CITY OF NOVI CITY COUNCIL DECEMBER 1, 2025

SUBJECT: Consideration tentative approval of the Camelot Parc Townhomes

Planned Suburban Low-Rise (PSLR) Overlay Development Agreement

<u>Planning Review</u> Camelot Parc Townhomes

HEET NO. 7

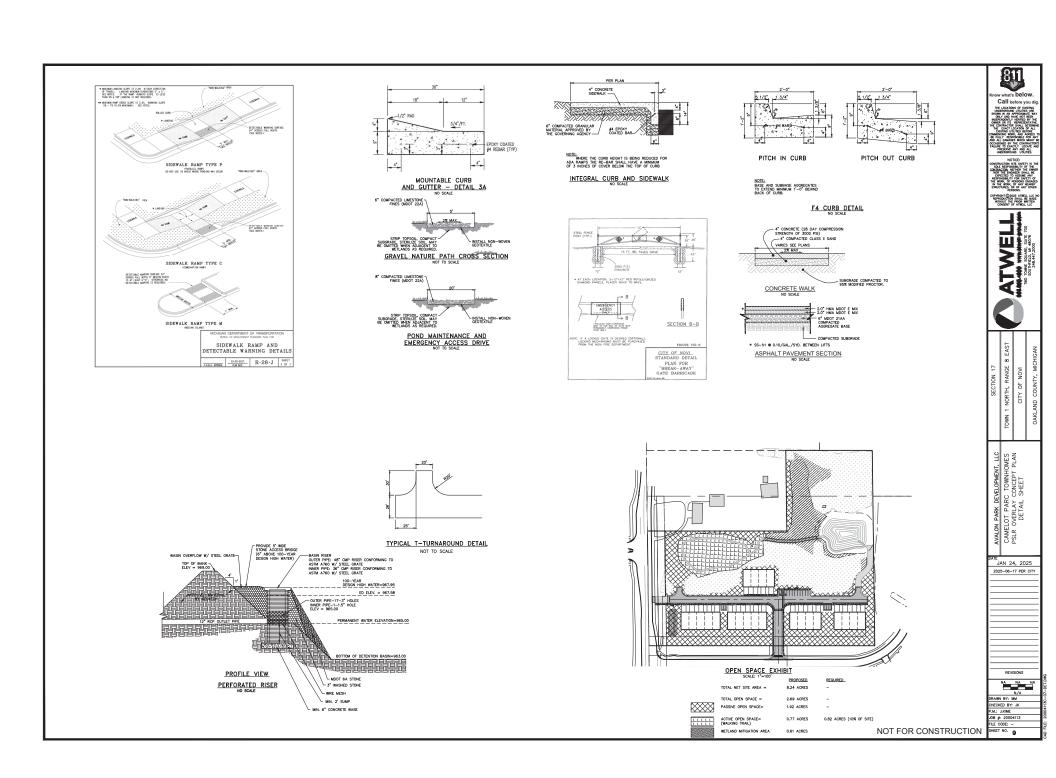
- **Requested edit**: the wetland type (classification) should be added to the table on Sheet 7. An update to the previous wetland delineation may affect the impact amounts listed above.

5. The wetland type (classification) should be added to the table on Sheet 7. An update to the previous wetland delineation may affect the impact amounts listed.

Response: The wetland classification (emergent, scrub, forested) has been added to the table on sheet 7.
